# IMPORTANT PRODUCT INFORMATION

**Product: IC693 DSM Module (“DSM302”) with Firmware Version 1.41  
IC693DSM302-AF**

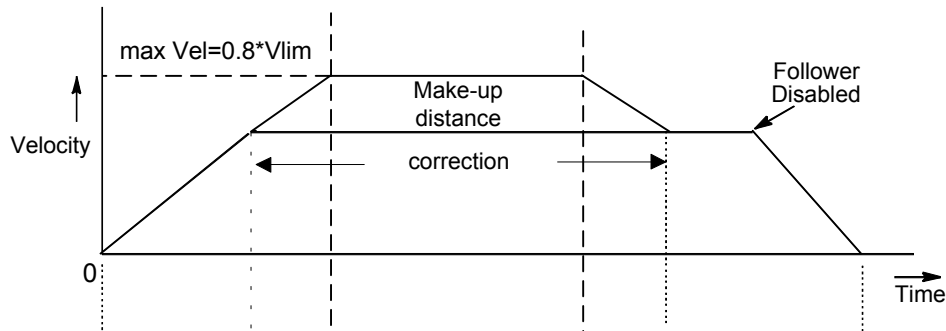
### Enhanced Follower Axis Ramp Control

The Follower Axis Ramp Control Function is enhanced in DSM firmware release 1.30. The enhancement improves motion smoothness. Prior to this release, when the follower was active and the master in motion, the acceleration/deceleration control during the make-up correction phase was not controlled by a velocity profile. This could cause unwanted machine shock. The enhanced method uses a trapezoidal velocity profile to address this problem. During the entire make-up correction phase, the acceleration/deceleration is limited to the jog acceleration value. Also during the correction, the velocity is not allowed to exceed the maximum. Appropriate warning/error codes notify the user about abnormal operation (see error table below).

The figure below shows the velocity profile during the follower ramp cycle. *Note: The enhanced follower make-up may affect existing applications that use the old follower make-up feature.*
